April 29, 2022

Road Safety Audit Belknap Street Fort Worth, TX

APRIL 29, 2022

Figure 26: Right turn slip lane design (TxDOT)

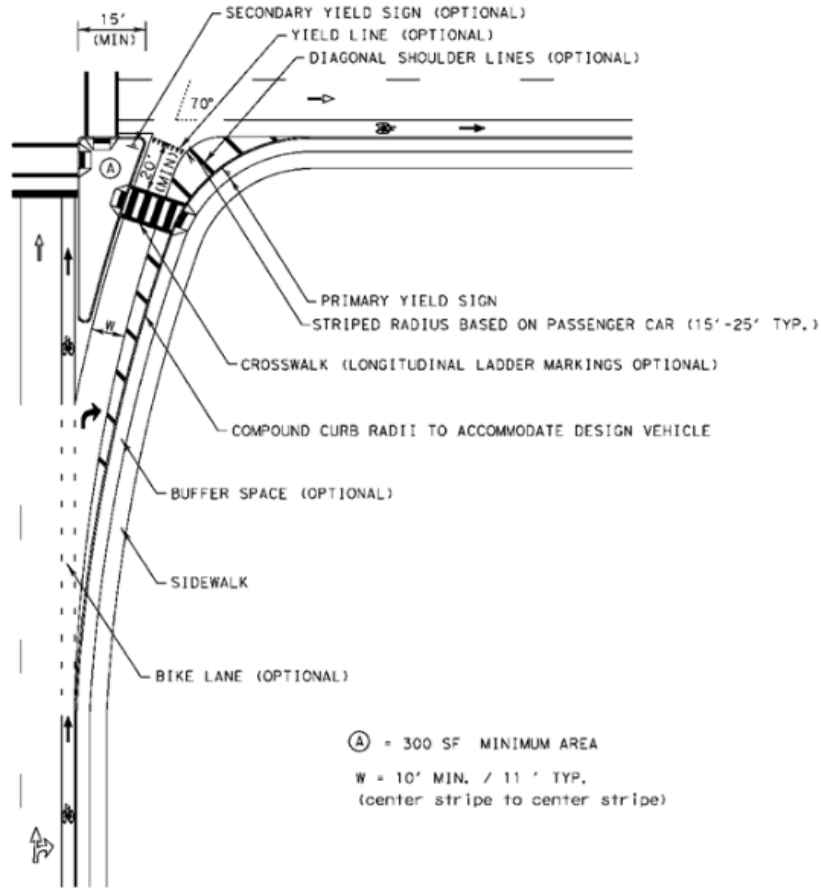
- **Observation:** The right turn movement from Belknap Street to North Henderson Street has no control (yield or stop signs, or pavement markings) or crosswalk pavement markings. Vehicle speeds were high for those turning right onto North Henderson since turning vehicles have their own lane until the Tarrant County College parking garage/Peach Street. **Recommendation:** Install yield sign and marked crosswalk. During future improvement projects, consider [TxDOT's new standard](#) for right turn islands, which tightens the right turn and provides improved visibility for crossing pedestrians. Timeline: Short-term for pavement markings, medium-term for right turn island.
